Product Change Notice (PCN)

Subject: Carrier tape change for Intersil Product ISL98611II56Z-T WLCSP Packaged Product

Appendix A – Carrier Tape Dimension – PCN15038 (see attached)

Appendix A – Carrier Tape Dimension – PCN15038
Existing Carrier tape (8mm)

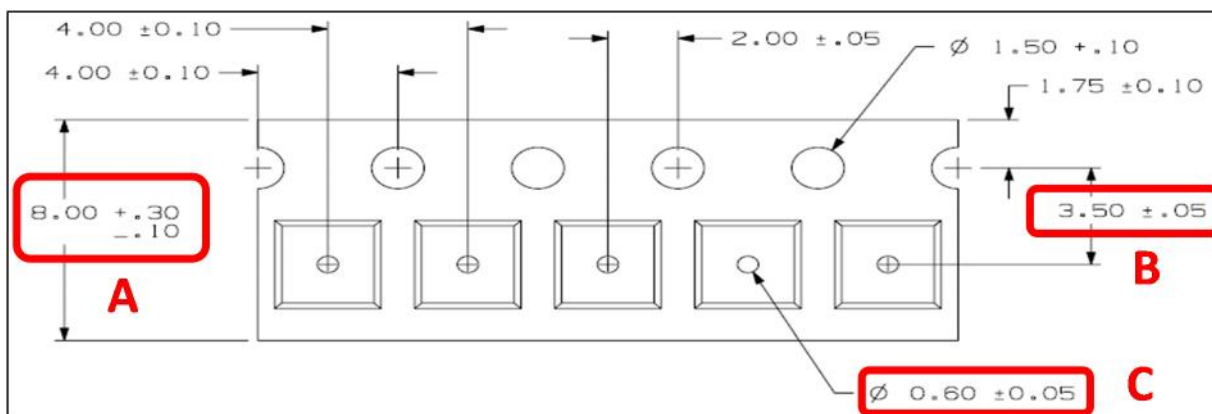
Carrier tape dimension change for Intersil Product ISL98611II56Z-T WLCSP Packaged Product

This notice is to inform you that Intersil has qualified a change that standardizes the carrier tape used for tape and reel packing of the listed Intersil ISL98611II56Z-T WLCSP (Wafer Level Chip Scale Package) packaged products. The new 12mm carrier tape has slight changes in the carrier tape dimension between the existing and new carrier tapes, which are not expected to affect the automated pick and place equipment used for board mount assembly operations. The carrier tape dimensions for the existing and new carrier tapes are shown in Appendix A.

#	Code	Dimension	Existing Carrier Tape	New Carrier Tape
1	A	Carrier Tape Width	8.00 mm + 0.30 mm - 0.10 mm	12.00 mm + 0.30 mm - 0.10 mm
2	B	Index Hole to Pocket Hole Width	3.50 mm $\pm$ 0.05 mm	5.50 mm $\pm$ 0.05 mm
3	C	Pocket Hole Diameter	0.60 mm $\pm$ 0.05 mm	1.00 mm $\pm$ 0.05 mm
